PLANNING COMMISSION MEETING NOVEMBER 3, 2016

PLANNING COMMISSION: NOVEMBER 3, 2016

MP-16-13 / Z-16-11 / CU-16-19 / V-16-26

SHEET NO **SP-43**

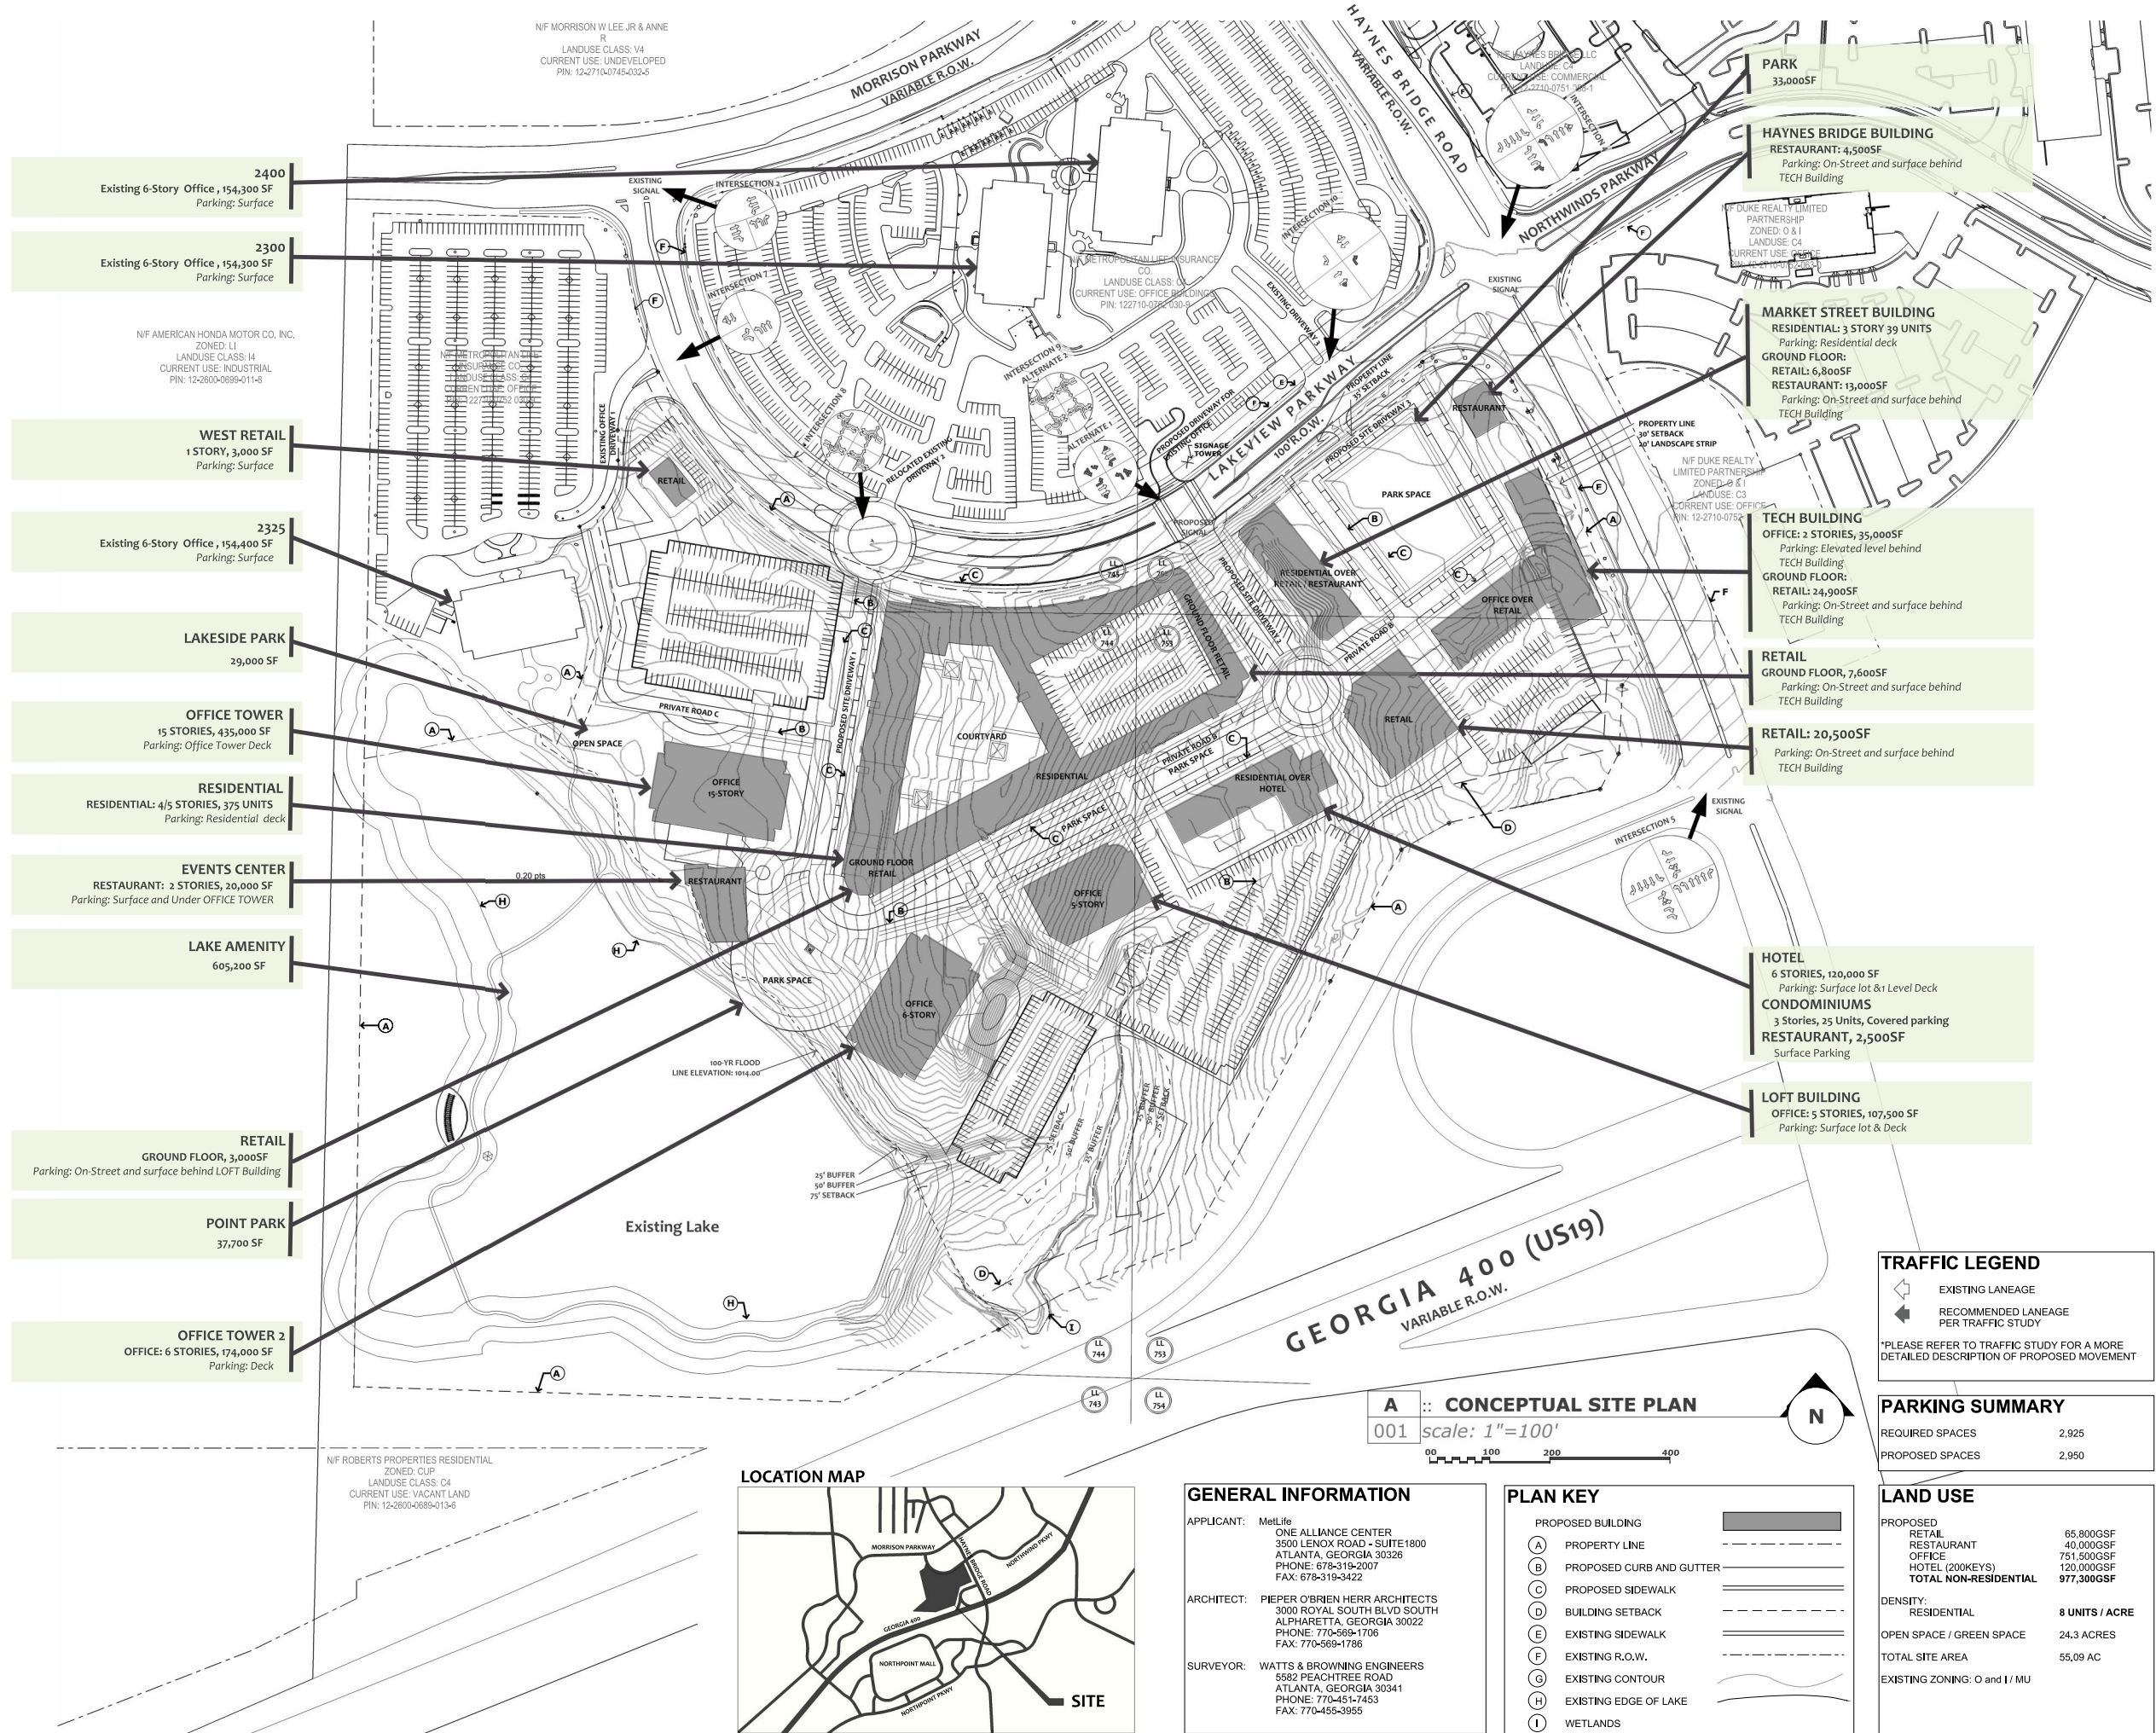
Staff has reviewed the application and is in general agreement with the requests for master plan amendment, rezoning, conditional use and variance. The proposed rezoning to MU is consistent with the vision of the Metropolitan Life/Peridot Master Plan, the North Point Activity Center LCI and Comprehensive Land Use Plan designation of the subject property, which includes a mix of uses within a walkable environment. However, the proposed number of 'For-Rent' units exceeds the annual target range recommended in the City's Rental Housing Study, as well as exceeding the City's desired balance between owner- and renter-occupied dwelling units. Therefore, staff recommends that no more than 220 'For-Rent' units be approved on the subject site in order to maintain the desired housing balance. In addition, staff recommends that the development provide at a minimum 25% of residential units as 'For-Sale' product.

Conditions are recommended to require Mercantile/warehouse architectural style, which is important to brand this particular mixed-use development and differentiate it from other mixed-use developments. Additionally, sufficient residential amenities and parks and recreational opportunities should be required in order to limit impacts on the City's parks. Concurrent construction of the retail, hotel, office and residential uses should be required in order to ensure the reduction in vehicular trips is realized.

1. The **62.47-acre** property shall be zoned MU. Site shall be developed substantially similar to plans by **Wakefield Beasley & Associates**, dated **9/28/2016**, subject to approved conditions. **Architectural style of all buildings shall be Mercantile/warehouse similar to the renderings in the 2015 application with non-residential buildings approved by the Design Review Board and residential buildings approved by Staff.**

2. Development regulations shall be as follows:
 - a. Office – **664,400** square foot maximum. Building height shall be limited as depicted on site plan dated **9/28/2016** with 1 building up to 12 stories, remaining office limited to a maximum **6** stories. Mixed use buildings shall be limited to a maximum of **4 stories or 60’, whichever is less.**
